Re: Demolition Referral for Willard Clubhouse Building

Subject: Response to Comments Regarding the Historical Resources Evaluation of

## Willard Park Community Clubhouse

Response to Memo from LPC member Steven Finacom

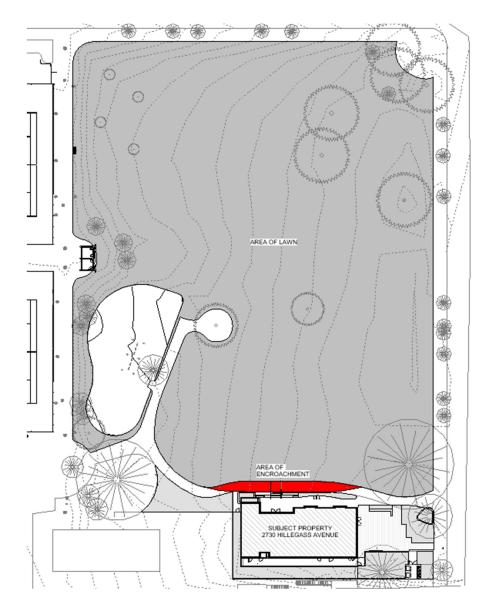
- 1. Salvage of the brass Frances Willard memorial plaque currently attached to the building and placement of it either on the new building or elsewhere in the park.
  - We agree with this suggestion and would propose that the plaque be mounted either on the east wall of the building facing out onto the terrace, or on one of the wood stumps at the south side of the new patio at the eastern end of the building.
- 2. Photo documentation of the existing building and its context in the park, with copies of the photographs deposited in local historical / architectural repositories.
  - We will provide such photo documentation and will deposit it to a repository per the direction of the LPC.
- 3. Design the new clubhouse to serve in the same way as the existing clubhouse, as a low-key, perimeter and peripheral built structure of the park, secondary to the open space

rather than as a visually dominant building in the park (this recommendation does not presuppose or mandate any specific architectural style)

We believe that our current design meets this recommendation. The proposed single-story building of 3,285 square feet with a maximum height of 15'-8" is located at the southern edge of the park that has a total area of 126,200 square feet. The height of the new building is lower than the homes bordering the park to the east and south, adjacent to the site of the clubhouse. The building area is equal to 2.6 percent of the total gross area of the site. In other words, the new structure is very small compared to the overall size of the park, so it will not be visually dominant.

The proposed location for the replacement clubhouse is in the same spot as the existing building, which is in the far southeast corner of the site, right up against the edge. We believe that this complies fully with the request for a perimeter and peripheral building. We studied other options within the park but agreed with comments from community members that the current location is the best spot for the new building.

The building has a linear footprint in direct response to the constraints of the specific site in the southeast corner of the park. These constraints include the fences, side and rear yards to the south and west, as well as 1 large heritage oak tree, a Japanese maple, and a heritage redwood tree. We worked with the city arborist to determine the required setbacks from the trunks of these trees, and that helped define the area in which the building could be sited.

Site plan illustrating the relocated path and area of encroachment into the existing lawn

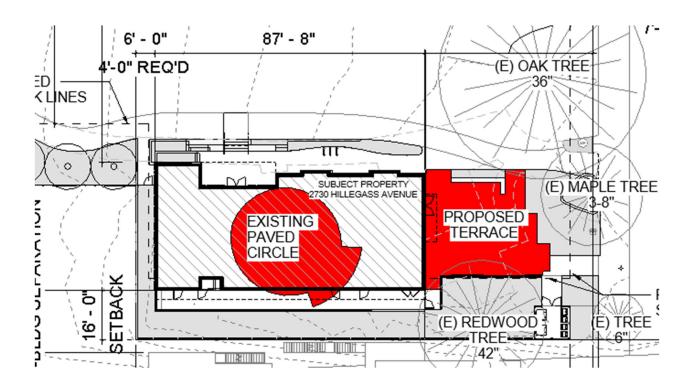
4. Additionally, reflect the placement of the clubhouse to avoid intrusion of the new clubhouse building and its supporting spaces/structures into the large, informal, multipurpose lawn area that is physically and conceptually "central" to the character of Willard Park.

The existing central lawn, including the playground, has an area of 84,384 sf. No part of the new building or its associated patio or trellis area project into that space.

Due to the existing contours of the site, and the requirement to provide an accessible path to and from the front door of the new building while also maintaining an accessible path into the park itself, we do need to reconfigure the path directly north of the building to allow for a parallel level pathway from the east and new stairs with flanking planters directly north of the entry door. This new pathway does project slightly into

the overall lawn area and we have requested a variance from the planning department to reduce the rear yard setback to minimize this impact. The current proposed design calls for a reduction in the lawn area equal to less than 1% (0.94%) of the total lawn area.

View of the building from the East

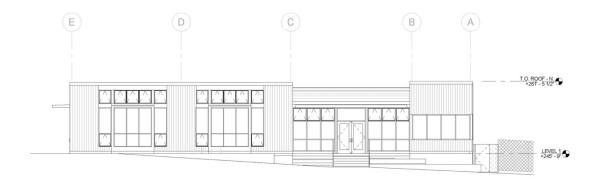
5. Design the new clubhouse to reflect the original in being a low-key "good neighbor" both in physical form and in function to adjacent residential structures and their residents.

At 15'-8" tall, the proposed new clubhouse is substantially lower than all of the neighboring residential structures, most of which are 2-3 stories in height. The proposed roof form of the new building is a simple shed, sloping from the north to the south. This is proposed because it is the optimal configuration for rooftop photovoltaic solar panels, which are being provided to enable this building to generate its own power onsite. This also complies with an upcoming code requirement that new public buildings of this nature be constructed with solar panels. Most of the neighboring homes have gable or shed style roofs, but providing a roof like that on the clubhouse would greatly reduce the area available for the solar panels.

Many of the neighboring homes have wood siding or shingles as their exterior finish, and a similar wood siding material is proposed for the new clubhouse.
